Ref: DA2025/0707
12 August 2025

RE: REQUEST FOR ADDITIONAL INFORMATION DA2025/0707
SITE: No.25 Marlborough Ave Freshwater (LOT 132 DP 1015612)

I refer to the Request for Additional Information (the RFI request) provided by Northern Beaches Council on 30 July 2025 in relation to Application No. DA2025/0707. The subject DA seeks consent for alteration and additions to a dwelling house at No.25 Marlborough Ave Freshwater.

2. Summary of Proposed Building Heights

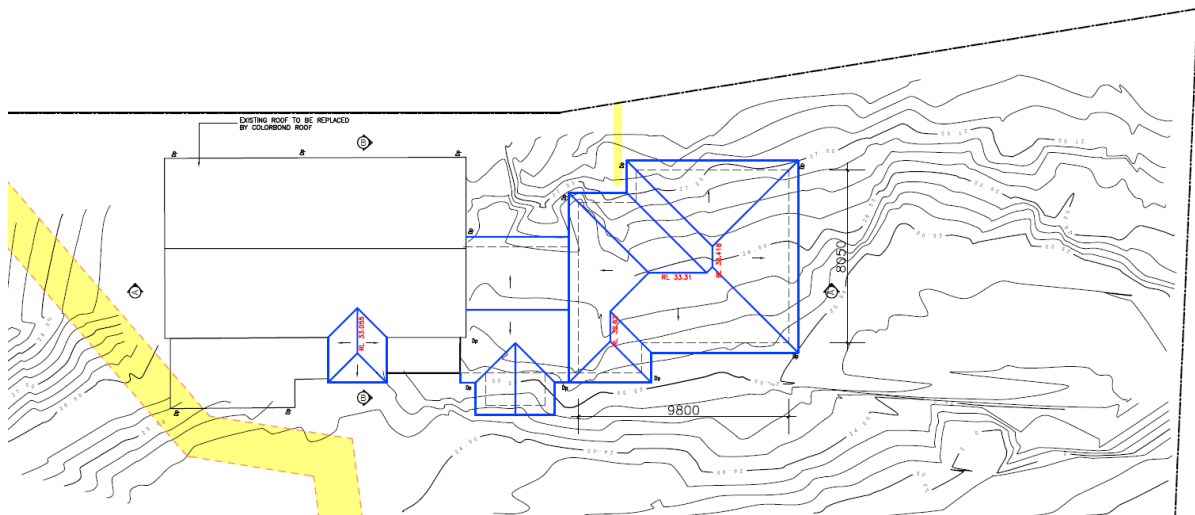
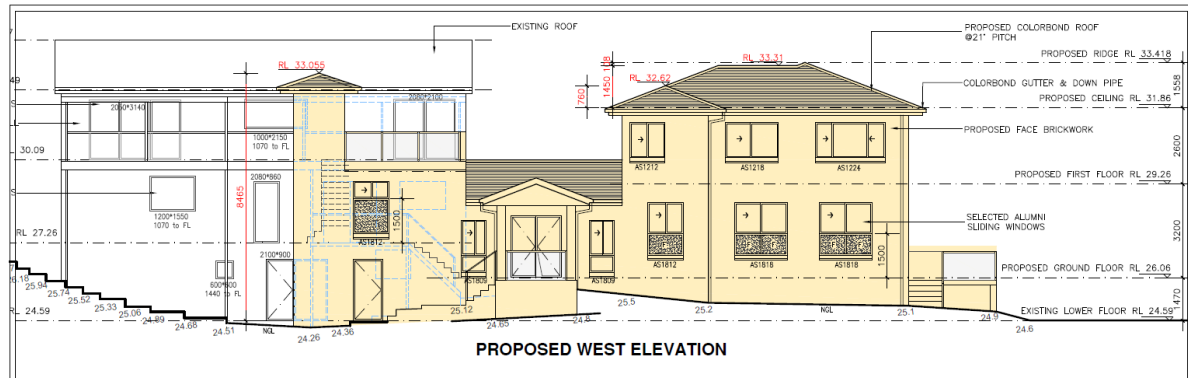
The plans do not reflect the proposed works clearly on the section plans and require greater clarification. The area of the proposed lift and proposed maximum building works should be clearly labelled on multiple section plans.

The maximum building height under this proposal is currently measured at 9.6m and presents a variation of 12.9% (1.1m). As such, a Clause 4.6 variation request report is required to demonstrate why it is unreasonable and necessary for the proposed works to comply with Clause 4.3 Height of Buildings and that there are sufficient environmental planning grounds. The application will also be subject to the Development Determination Panel due to a variation greater than 10% to the development standard.

An additional section plan has been prepared to clearly indicate the location and height of the proposed lift.

Building Element	Ridge Level (RL)	Ground Level (RL)	Height Above Ground Level (m)
Top ridge of proposed two-storey building	33.418	25.900	7.518
Lower ridge of proposed two-storey building	33.310	25.900	7.410
Lowest ridge of proposed two-storey building	32.620	25.500	7.120
Ridge connecting existing roof to new lift area	33.055	24.590	8.465

The height (9.6m) from the existing roof ridge to the existing ground level marginally exceeds Council's prescribed height limit. This exceedance does not result from the proposed works but is an established characteristic of the existing dwelling, which has been constructed on a steeply sloping site. The proposed alterations and additions do not further increase the height beyond the existing condition and have been designed to minimise bulk

2. Development Engineering Officer concern

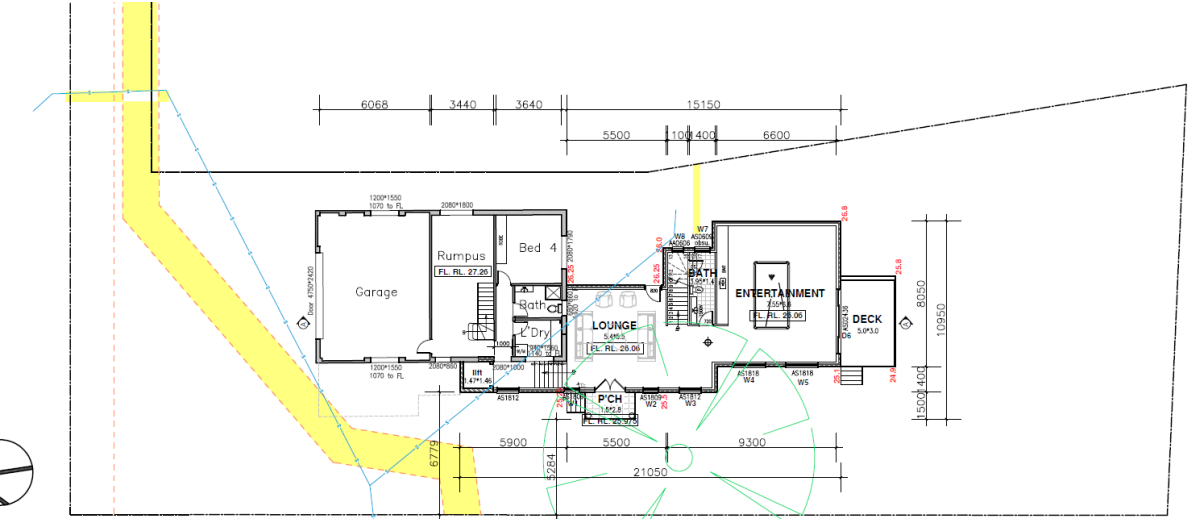
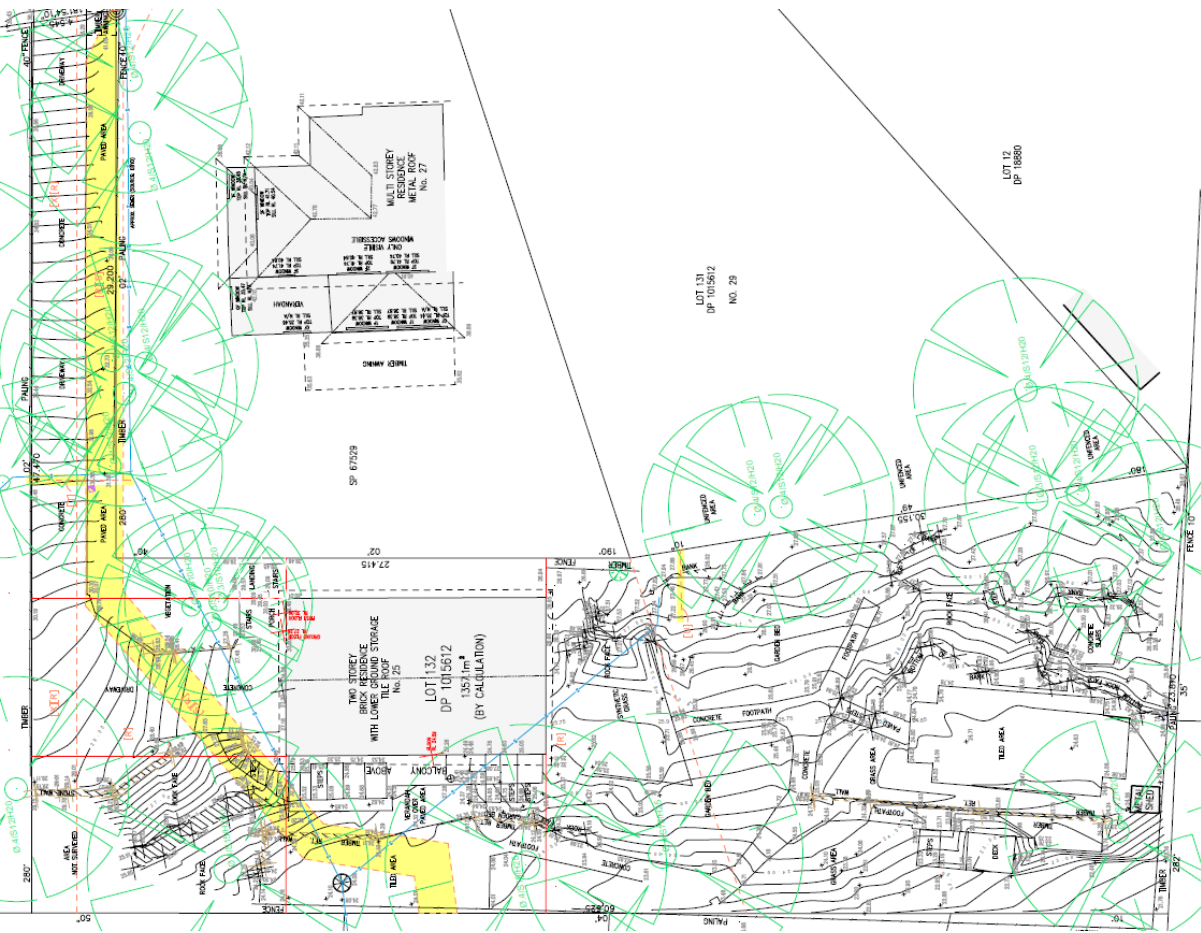
All structures must be positioned clear of any Council pipeline or easement, in particular the proposed lift and stairs in the lower ground floor. Details position of the Council's pipeline are to be plotted in the survey plan and DA plans.

Following confirmation with the surveyor, we advise that the proposed extension — including the lift and stairs — is clear of any Council pipeline or easement. The blue “s-s-s-s” line shown on the plans represents the **Sydney Water sewer pipeline**, not a Council asset. The minimum

setback from the proposed lift to the easement is at least **3m**. The **easement is identified in the yellow highlighted area** on the plans for clarity.
